**Committee of Experts on the Transport of Dangerous Goods  
and on the Globally Harmonized System of Classification  
and Labelling of Chemicals**

**Comments on document ST/SG/AC.10/C.3/2022/50  
–ST/SG/AC.10/C.4/2022/10 : Amendments to the  
classification of desensitized explosives according to the GHS**

**Transmitted by the Australasian Explosives Industry Safety Group  
(AEISG)**

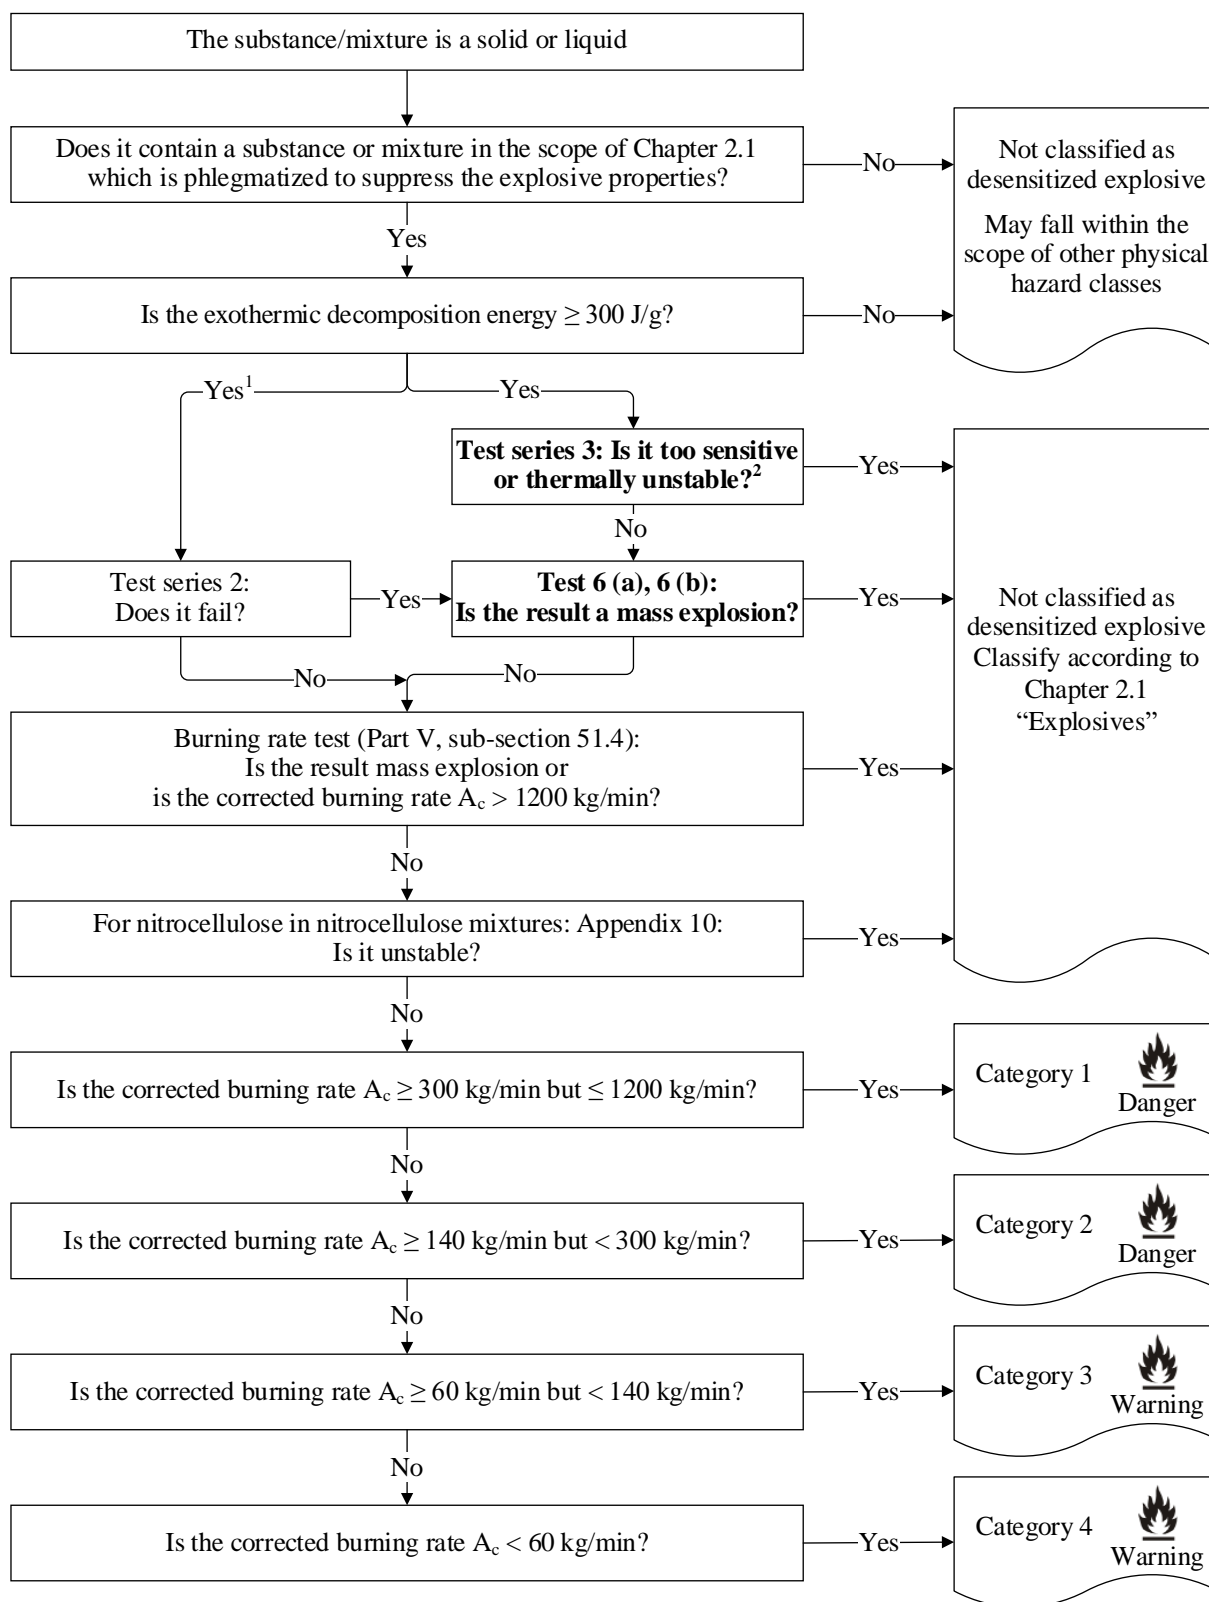
14. It is suggested that, to be consistent with the principles in 10.3.3.4 of the Manual, the tests series 3 and tests 6 (a) and 6 (b) referenced in the decision logic proposed in document ST/SG/AC.10/C.3/2022/50 –ST/SG/AC.10/C.4/2022/10 be reversed in order so that test series 3 is conducted prior to Test 6 (a) and (b). This follows the principle of first determining how sensitive a material is before doing larger tests on it.

15. In decision logic 2.17.1 in document ST/SG/AC.10/C.3/2022/50 –ST/SG/AC.10/C.4/2022/10, reverse the order of the boxes referring to test series 3 and test series 6 (a) and (b) as indicated (*reversed boxes are shown in bold*):
